APPLICATION NO.	FILING DATE	FIRST NAMED INVENTOR	ATTORNEY DOCKET NO.	CONFIRMATION NO.
10/623,588	07/22/2003	Gary Schlatter	ORA-005	5846
21984 7590 09/08/2008 WELSH & FLAXMAN LLC 2000 DUKE STREET, SUITE 100 ALEXANDRIA, VA 22314				
EXAMINER				
SMALLEY, JAMES N				
ART UNIT		PAPER NUMBER		
3781				
MAIL DATE		DELIVERY MODE		
09/08/2008		PAPER

Office Action Summary

DETAILED ACTION

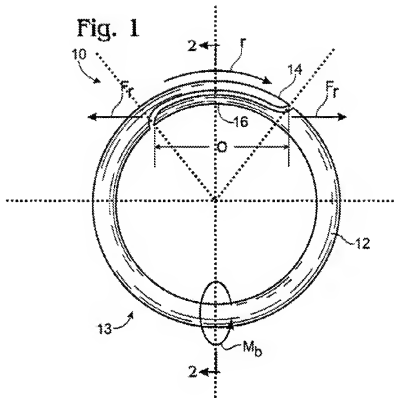
Examiner notes, however, in the diagram provided below taken from Christler '191, figure 1, superposed lines have been drawn to estimate the center of the ring, and then show the arc length of the overlap relative to the center. It is clear that the arc overlap is slightly less than 90 degrees, and more specifically is likely greater than 60 degrees.

Examiner notes the claim only requires "at least 60 degrees". See figure provided above showing what appears to be an overlap of greater than 60 degrees.
